<b>JRPP No:</b>	2010NTH015
<b>DA No:</b>	DA 135-2010
<b>PROPOSED DEVELOPMENT:</b>	<p><u>Proposed Development:</u> New Motel with 51 guest rooms, Manager's Unit and car park, modifications to existing Armidale Ex-Services Memorial Club and Belgrave Twin Cinema buildings, modification of existing car park and site remediation works.</p> <p>The development is proposed to be undertaken in three (3) stages - consent is sought for all three stages as part of this Application.</p> <p><u>Address:</u> 137 Dumaresq Street, Armidale (comprising Lots 1 and 2 DP 770624, Lot B DP 157581 and Lot 22 DP 869146) and 86-88 Dangar Street Armidale (comprising Lot 3 DP 1131420 and Lot 1 DP 1136216).</p>
<b>APPLICANT:</b>	Armidale Ex-Services Memorial Club, c/- Team Design Aust.
<b>REPORT BY:</b>	Paul Creenaune, Planner, Armidale Dumaresq Council
<b>REPORT REVIEWED BY:</b>	Stephen Gow, Director Planning and Environmental Services, Armidale Dumaresq Council.

## Assessment Report and Recommendation

Figure L2 of the Floodplain Development Manual (reproduced below showing relevant flood depth of 0.57m and velocity of 1.25m/s marked) indicates that the Provisional Hydraulic Hazard Category for the site falls between Low and High Hazard (closer to high).

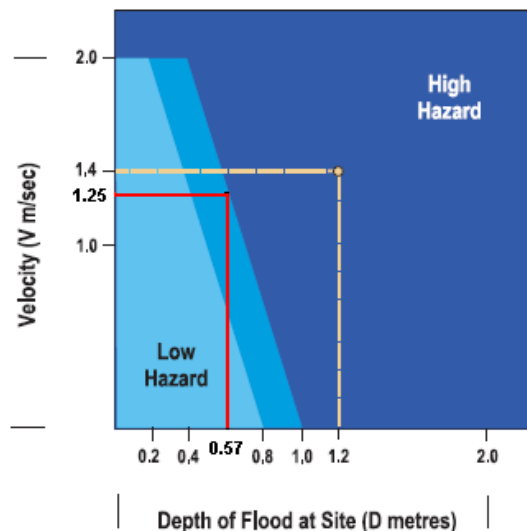
Council has concerns with this analysis as the two hazard levels, as identified in the Floodplain Development Manual - Appendix L Hydraulic and Hazard Categorisation, are either Low hazard or High hazard. An analysis of the 1% AEP flood data supplied by the Consultant shows a depth of 0.57 metres and a velocity of 1.25m/s in Dumaresq Street outside the entrance to the development. Further analysis of the information supplied indicates that the depth of water increases along the proposed evacuation route to at least 0.65m, and to 0.8m at the gutter crossing near the corner of Dumaresq and Dangar Streets.

The Floodplain Development Manual (pg. L-4) states that *it is not appropriate to use Figure L2 to determine the hazard implications of individual developments*. Further hydraulic categories are provided in the Floodplain Development Manual, being flood ways, flood storage and flood fringe. In this case the Hydraulic Category is Floodway as Dumaresq Street operates as a secondary floodway when flood flows split at the Jessie and Dumaresq Streets intersection. Noting the above, it is considered that the Provisional Hydraulic Hazard Categorisation for the site would be High Hazard Floodway, not Intermediate Hazard as purported in the Flood Impact Report.

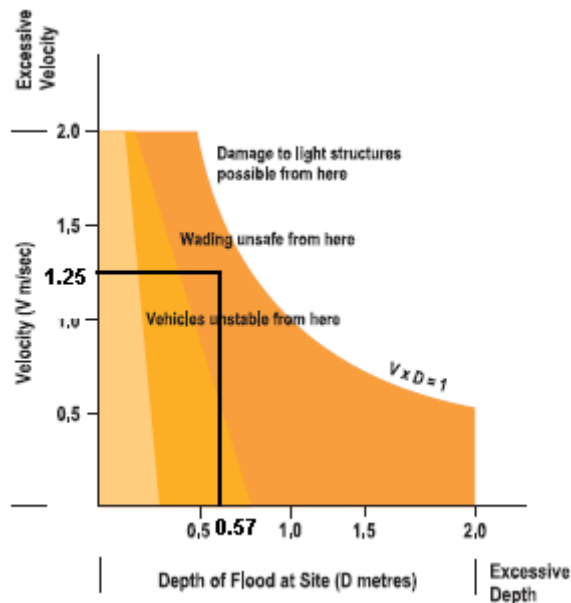
The flood emergency response plan includes an option for evacuation in certain circumstances. Despite the Flood Impact Report indicating, in relation to flood hazard classification, that evacuation is not feasible during the peak of a 2% AEP (or less frequent) flood event, the Report goes on to say that *the following aspects of the development will assist in the evacuation in the event of a major flood event such as the 1% AEP event or larger floods:*

Applying the depth and flow velocity data for the site to the Floodplain Development Manual Figure L1 – Velocity and Depth Relationships (reproduced below showing flood depth of 0.57m and velocity of 1.25m/s marked), it can be seen that evacuation during a 1% AEP flood event is inherently unsafe as vehicles become unstable and wading is unsafe, contrary to claims in the Report.

Furthermore, Council's analysis indicates that flood depths would increase along the designated evacuation route up to 0.65m on the footpath at the south-west corner of Dumaresq / Dangar Streets. The depth of water in the gutter at this location would be at least 0.8m. Occupants evacuating from the site would also be required to cross the submerged gutter in Dumaresq Street during a 1% AEP flood. In this regard, the evacuation route also does not provide *even grades* along its route, as suggested.
